TITLE RC-44 (RC-V2) Motor Burnout #2 (OCONEE-1,2,3)

CUSTOMER Duke Power Company	CONTRACT NO. 600-0003	SPR NO. 560	REV. NO. 0
VENDOR B. & W.	P.O. NO.	TASK NO. 28	GROUP NO. 41
SITE ENGINEER E. L. Logan	REQ'D. RESOL. DATE	REQ'D. COMP. DATE	
TITLE RC-4 (RC-V2) MOTOR BURNOUT

SUBJECT: Oconee 1, 2, and 3
Dresser Shutoff Valve KCV2

FIGURE 1

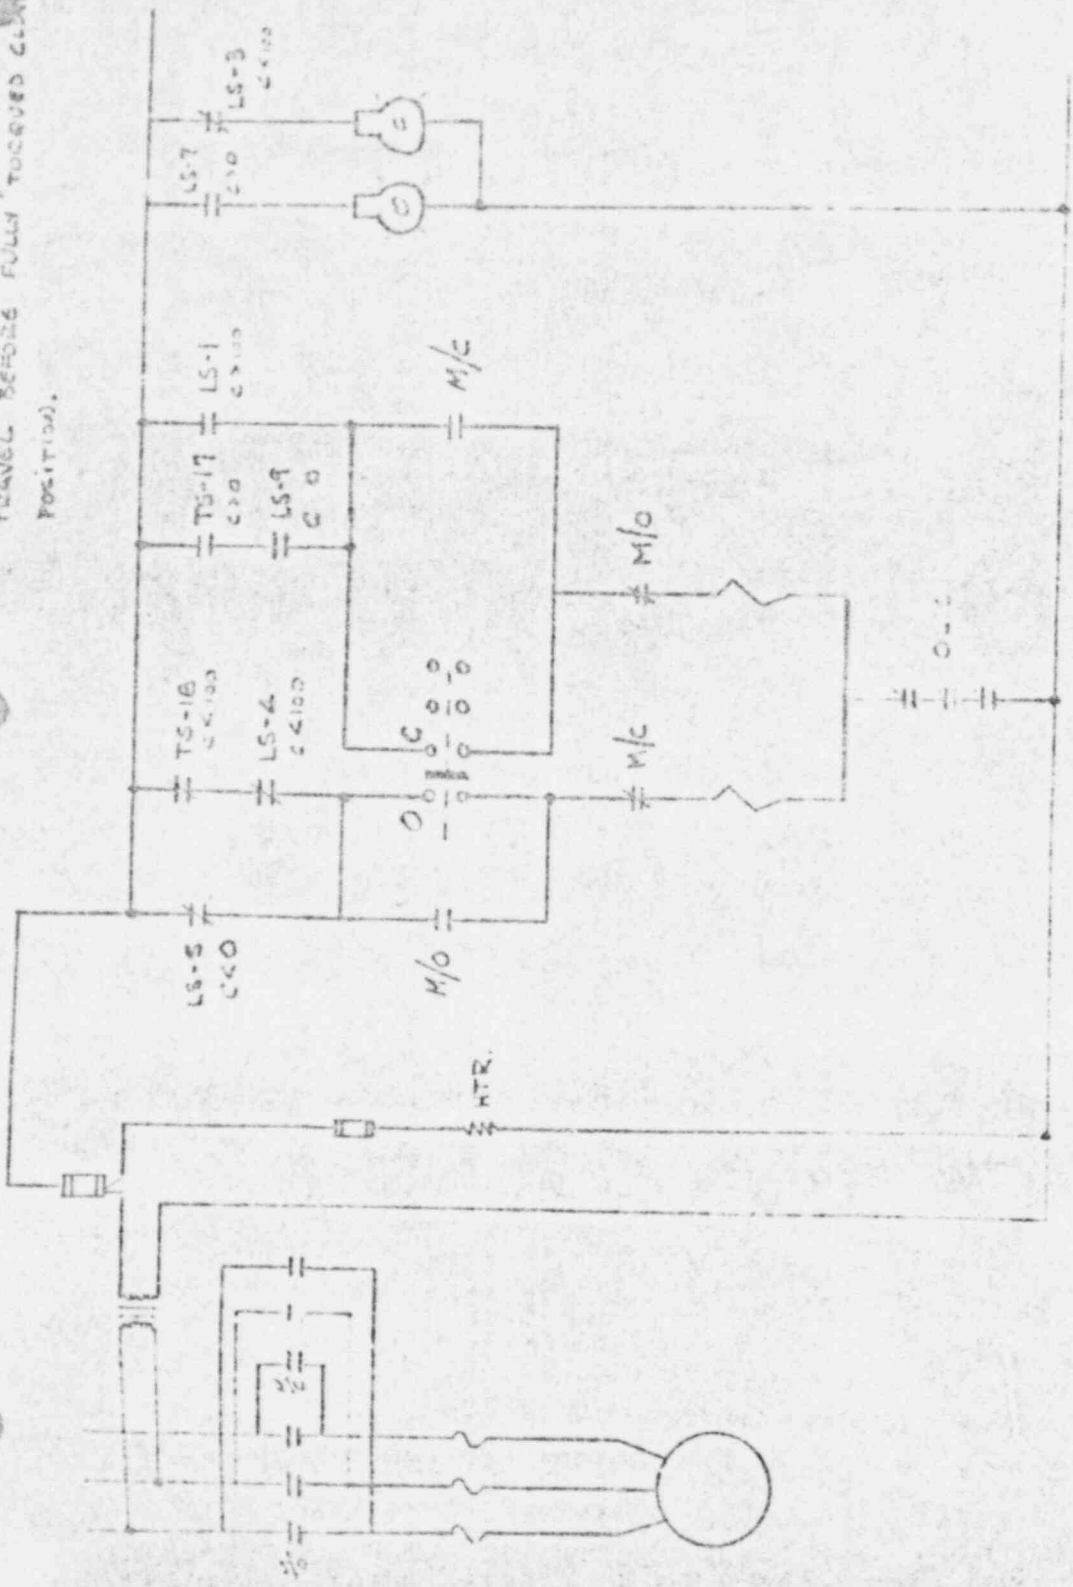
Limit Switch LS-9 was added to the 1 RC-V2 circuit on 12/12/73. (See Fig. 1) The switch was set to stop valve travel at 4 turns of the handwheel from the full closed position. This appears to have solved the opening problem as this valve was opened on 12/16/73 at full temperature and pressure. Now the valve cannot be closed. Two attempts were made on 12/17/73 and both times the overloads tripped. The 15 ft # motor is evidently not strong enough to start the valve toward the closed position.

NOTE: LS-9 ADDED 11/17/73 TO STOP VALVE TRAVEL BEFORE FULLY TO CLOSED POSITION.
